**W1**

(1975)  
(Rev.1  
1984)  
(Rev.2  
May 2004)  
(Rev.3  
Aug 2016)  
(Rev.4  
Apr 2021)

# **Material and welding for ships carrying liquefied gases in bulk and ships using gases or other low-flashpoint fuels gas tankers**

**Figure 1 Sampling position of Charpy V-notch impact test specimens (Base metal)**

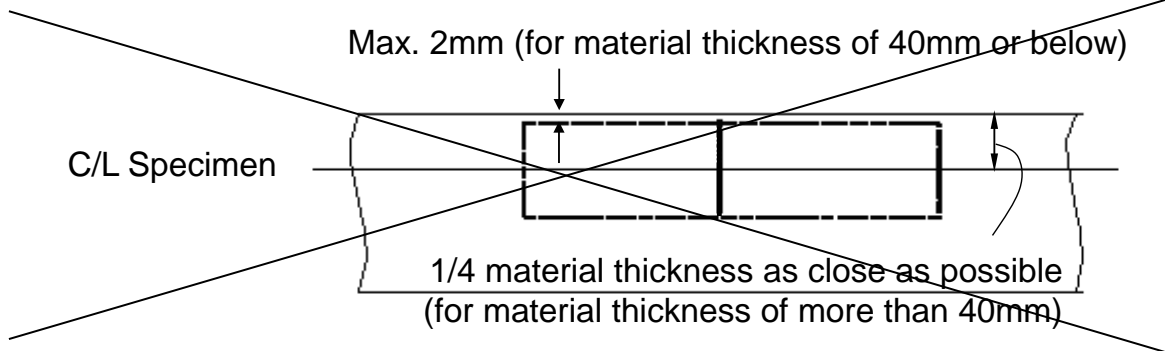
~~For base metal, the largest size Charpy V-notch impact test specimens possible for the material thickness shall be machined, with the specimens located as near as practicable to a point midway between the surface and the centre of the thickness and the length of the notch perpendicular to the surface as shown in Figure 1. In the case where the material thickness is 40mm or below, the Charpy V-notch impact test specimens shall be cut with their edge within 2mm from the "as rolled" surface with their longitudinal axes either parallel or transverse to the final direction of rolling of the material.~~

**Figure 2 Sampling position of Charpy V-notch impact test specimens (Weld)**

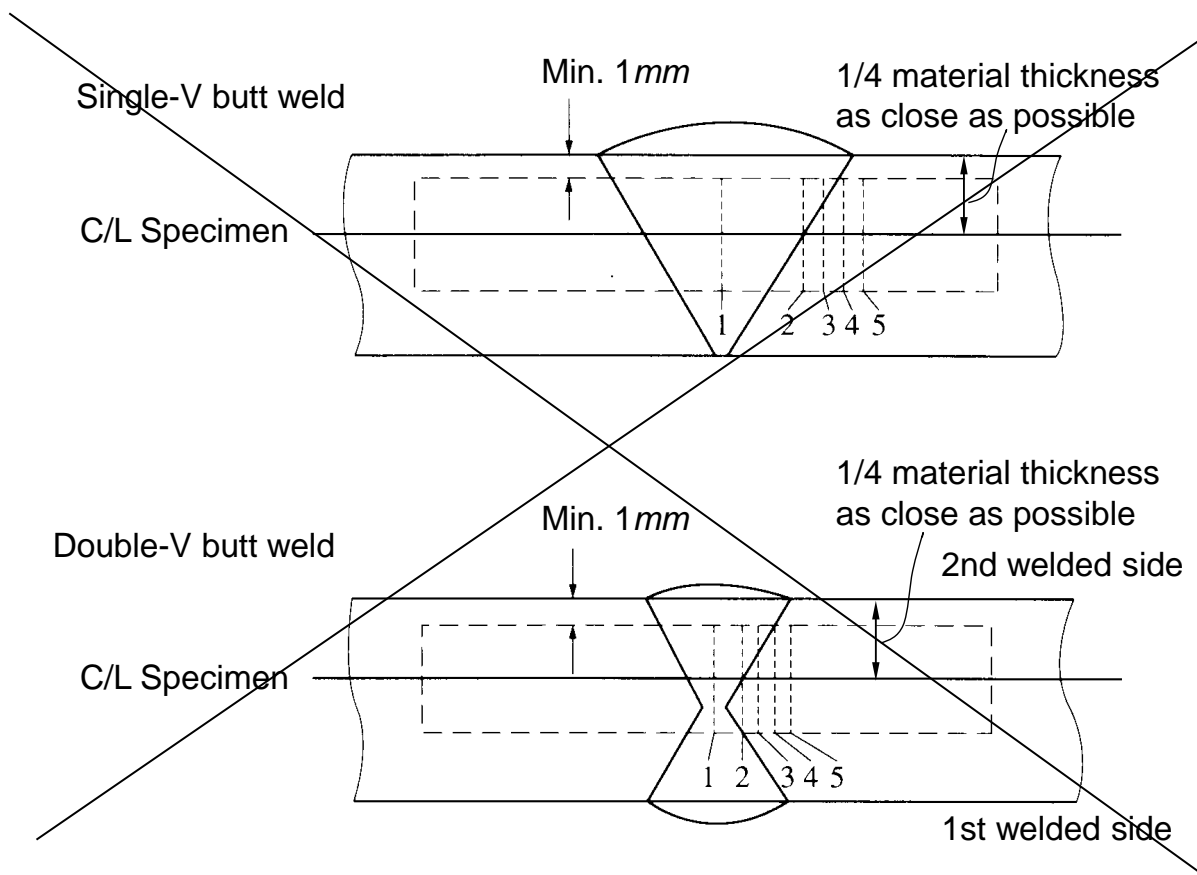
~~For a weld specimen, the largest size Charpy V-notch impact test specimens possible for the material thickness shall be machined, with the specimens located as near as practicable to a point midway between the surface and the centre of the thickness. In all cases, the distance from the surface of material to the edge of the specimen shall be approximately 4mm or greater. In addition, for double-V butt welds, specimens shall be machined closer to the surface of the second welded side. The specimens shall be taken generally at each of the following locations, as shown in Figure 2, on the centreline of the welds, the fusion line and 1mm, 3mm and 5mm from the fusion line.~~

### (iv) — One set of three Charpy V-notch impact test specimens, generally at each of the following indications (see Fig. 2):

- (1) — Centre line of the welds
- (2) — Fusion line (F.L.)
- (3) — 1mm from the F.L.
- (4) — 3mm from the F.L.
- (5) — 5mm from the F.L.
